P94-069 - AUTO SERVICE/TOWING FACILITY

- REQUEST:
- A. Negative Declaration
  - B. Mitigation Monitoring Plan
  - C. Plan Review to allow a 2,100 square foot auto/towing service facility and storage yard on 0.6± vacant acres in the Light Industrial - Review M-1S(R) zone.

LOCATION: 1552 Main Avenue  
237-0060-015  
North Sacramento Community Plan  
Grant School District  
Council District 2

| DATE: _____ | BY: _____ | F.E.G. | RALEY BLVD<br>TOW & STORAGE | SCALE: _____ | SITE PLAN | DATE: _____ | BY: _____ |

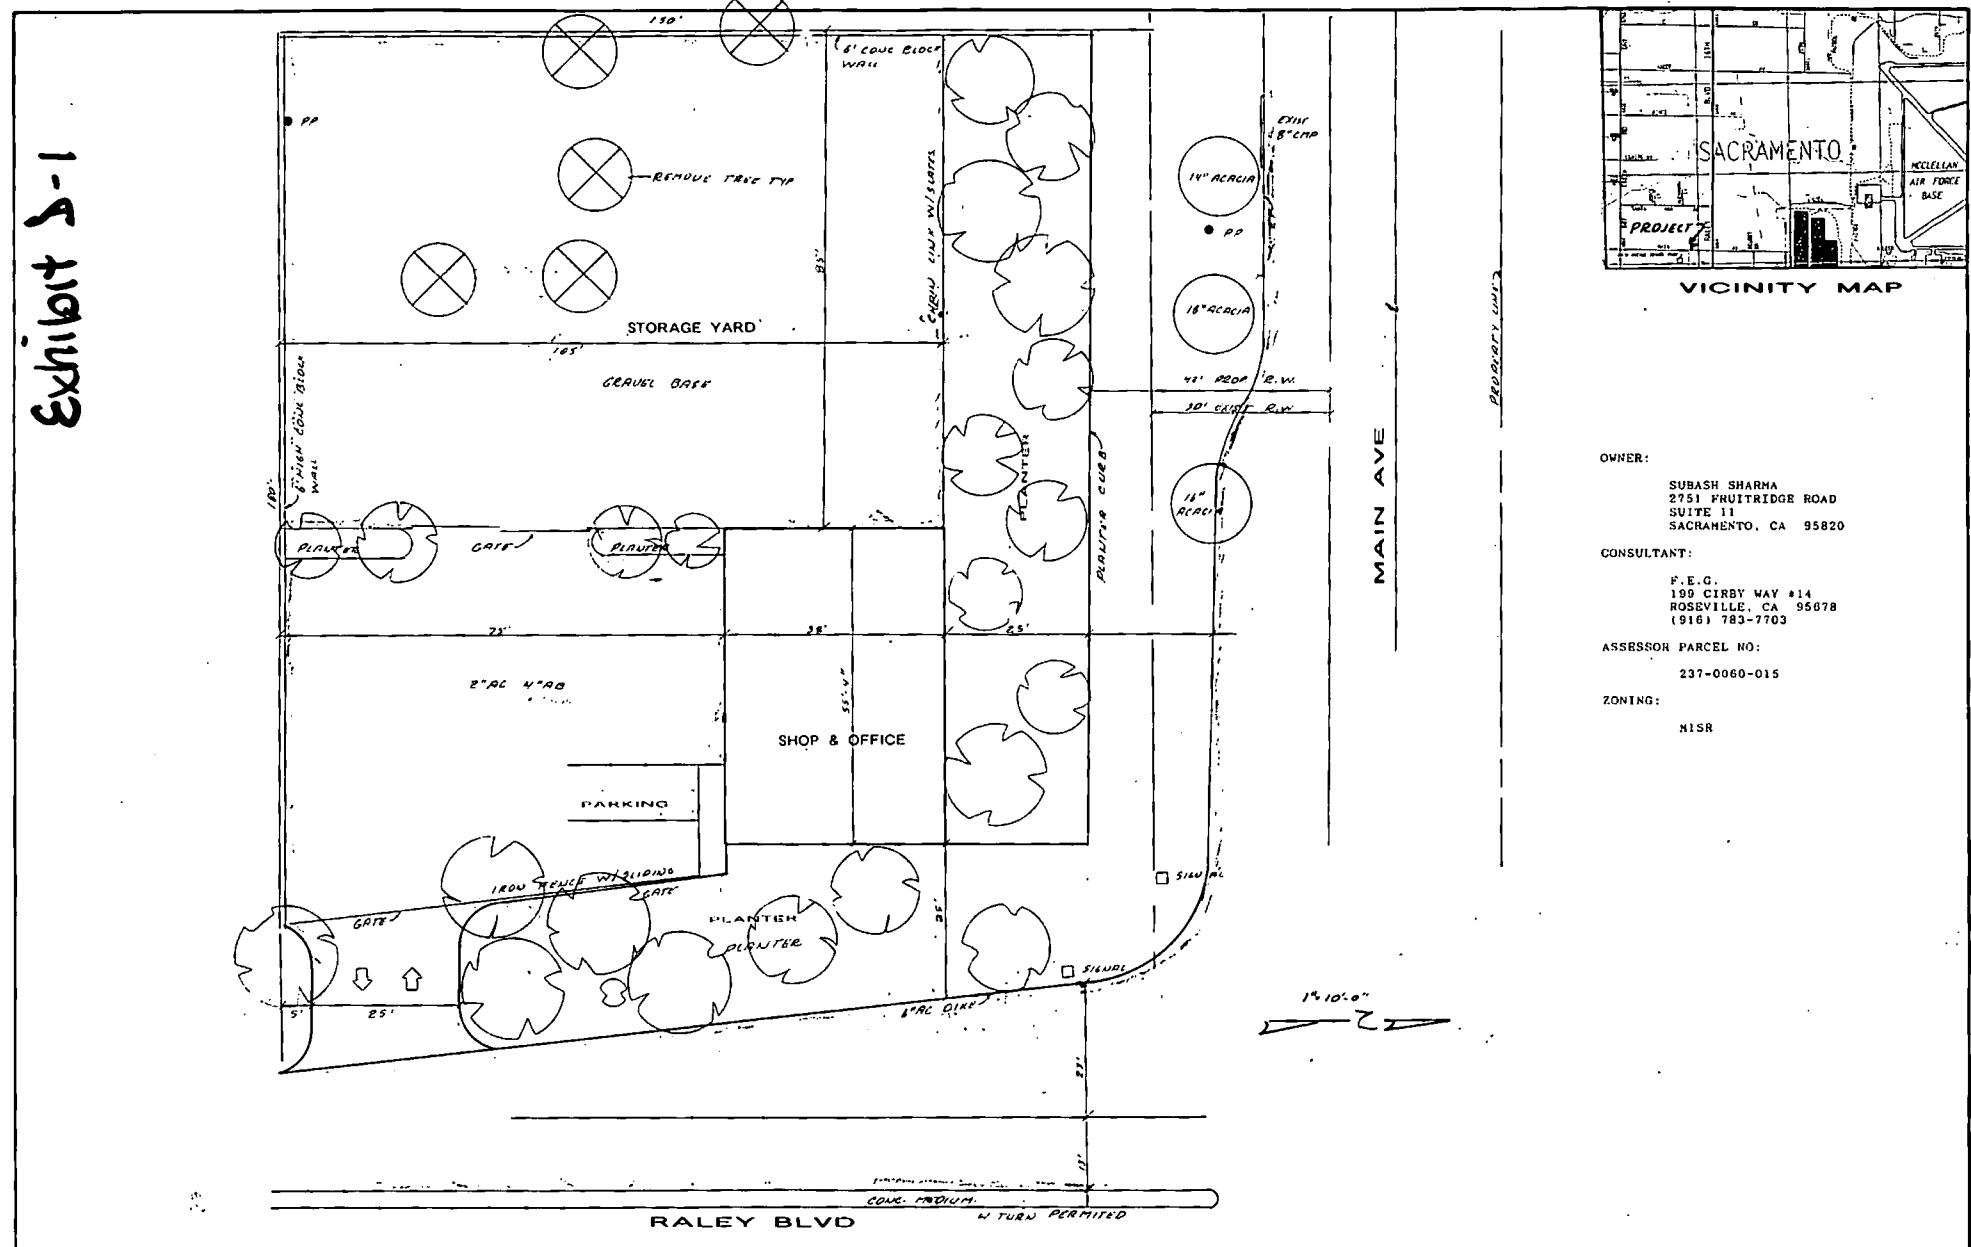
The M-1S(R) zoning requires a 25 foot landscape setback along all street frontages and complete screening of all outdoor storage. The site plan indicates a six foot high block wall along the west and south property lines, and a chain link fence with slats along a portion of the north property line, facing Main Avenue. An iron fence with a sliding gate will be provided along the east property line facing Raley Boulevard. The site plan also depicts a gate between the parking lot and the storage yard (see Exhibit D-1). The proposed chain link fence facing Main Avenue shall provide vinyl slats for screening of the storage yard. Additionally, the proposed gate between the storage yard and parking lot should consist of a solid masonry material and/or chain link fence with vinyl slats to screen the storage yard from Raley Boulevard. All fencing proposed on the site should be six feet in height and the solid block walls should be six feet high, as proposed.

The site plan does not indicate a trash enclosure location and/or a garbage receptacle(s). If garbage receptacles are used, the receptacles must be located solely within the building. If a trash enclosure is provided, the enclosure must meet all requirements of the Zoning Ordinance, including perimeter landscaping, masonry walls, and a solid metal gate. The trash enclosure must be located in an area that will not encroach into the designated parking and landscape areas. The applicant must also comply with the Recycling Ordinance.

The Zoning Ordinance requires a minimum of two parking spaces, one of which should be handicap, on the site. The submitted site plan indicates two parking spaces. Staff has no objection to the amount of parking spaces provided. The handicap space must be 14 feet wide and lined to provide a nine foot parking area and a five foot loading and unloading area. Fifty percent shading must be provided for the designated parking, maneuvering and driveway areas depicted on the site plan. There is one driveway for ingress and egress indicated off of Raley Boulevard. This driveway entrance/exit is gated. No bicycle parking spaces are required for the proposed use.

The Zoning Ordinance requires standard paving and drainage for all parking and storage areas. The site plan indicates a gravel base in the storage yard and a two inch asphaltic paving over a four inch aggregate base rock for the parking, maneuvering and driveway areas. The parking and driveway areas paving material is consistent with code but the storage yard paving does not comply with City code. Impounded vehicles will be stored in the storage yard. Section 2-39-C requires that outdoor storage areas be surfaced in the following manner:

The site plan depicts the required 25 foot landscape setback along both Raley Boulevard and Main Avenue. No landscape plan has been submitted. Staff recommends that the applicant submit a detailed landscape plan for review and approval of Planning Staff prior to issuance of Building Permits. The landscape plan shall include the irrigation system, the front setback landscaping along Raley Boulevard and Main Avenue, as well as compliance with the 50 percent shading requirement. Planters shall be of minimum widths to support the indicated trees, and shall indicate six inch curbs where appropriate. The landscape plans should also indicate compliance with the Water Conservation Ordinance.

The submitted site plan indicates that a few of the existing trees will be removed. Additionally, trees within a planter are shown on the plan. The City's Tree Arborist visited the site and discovered that many of the existing trees along the Raley Boulevard and Main Avenue will be within the public right-of-way when street widening occurs. It is also unclear how many trees will be removed in the designated storage area and/or if the existing trees along Raley Boulevard will be removed or replanted. The City's tree arborist is recommending that the applicant provide a site plan plotting adjacent trees to scale (trunk diameter and dripline of tree) along the west property line and Raley Boulevard and identify on the site plan new trees, trees to remain and trees to be removed and/or replaced. No trench type footing shall be permitted within the dripline of trees to remain on the site.

The City Arborist is recommending that site plan be submitted plotting adjacent trees to scale (trunk diameter and dripline of tree) along the west property line and Raley Boulevard. The site plan should identify new trees, trees to remain and trees to be removed and/or replaced. No trench type footing shall be permitted within the dripline of trees to that will remain on the site.

Detailed elevations of the six foot high block walls and the proposed fencing facing Raley Boulevard should be submitted for review and approval of Planning Staff prior to the issuance of Building Permits.

The applicant will be required to meet the paving and drainage requirements for all paved surfaces including the identified storage area.

A ELEVATION 1/4"=1'-0"

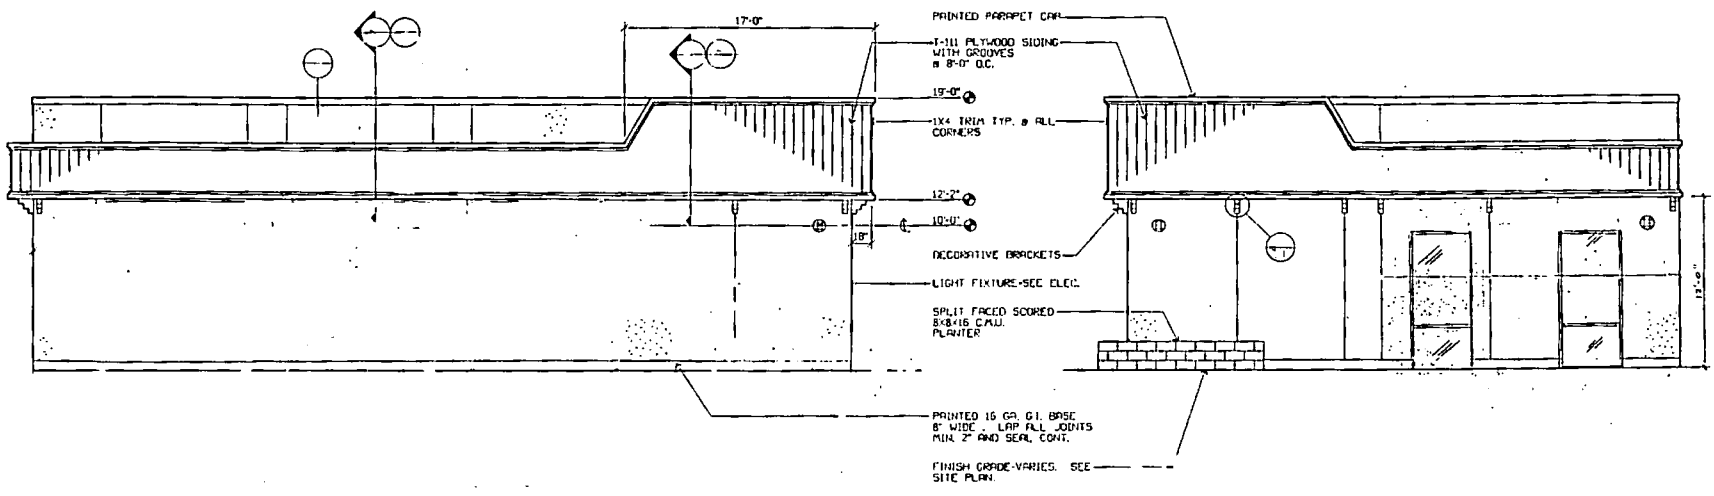
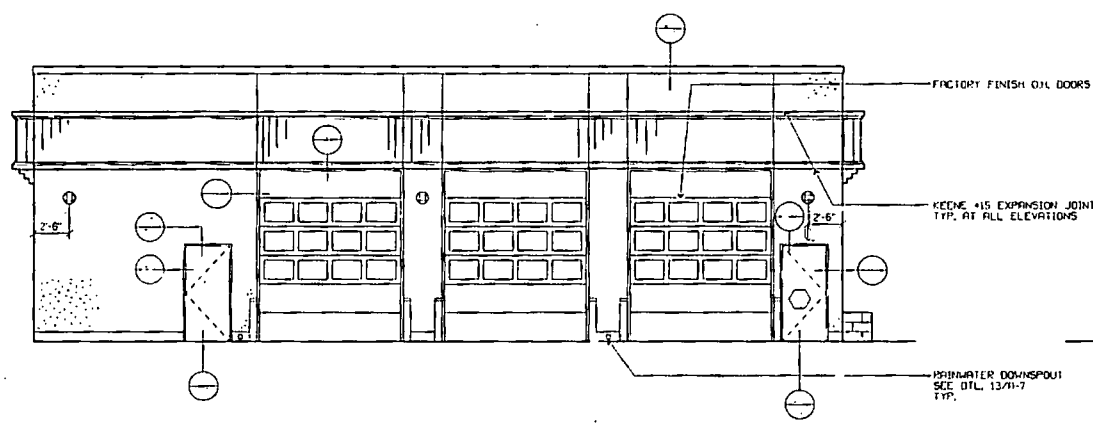
No signage is proposed on the site nor on the submitted elevations. All signage will be required to comply with the City's Sign Ordinance and the signs will be required to obtain sign permits. The Zoning Ordinance allows one detached monument sign for each street frontage in the M-1S zone. The detached monument sign shall not exceed ten feet in height, measured from the sidewalk or parking lot, whichever is lower. Sign area shall not exceed 48 square feet. Because this is a corner lot, two attached signs for each occupancy is allowed. The attached signs shall not exceed a total aggregate area of three square feet of sign area for each front foot of building occupancy.

The applicant proposes to construct a tilt-up stucco with wood trim building at a height of 16 feet. The colors include red strips on a white base. The roof material will be built up. Design Review staff is not opposed to the buildings design or color proposal but did suggest that an awning be placed above the main entrance to better define the entry. The proposed design, building material and architectural embellishments will enhance the overall building. The building's design will be compatible with the surrounding area and will help minimize the potential blight in the area.
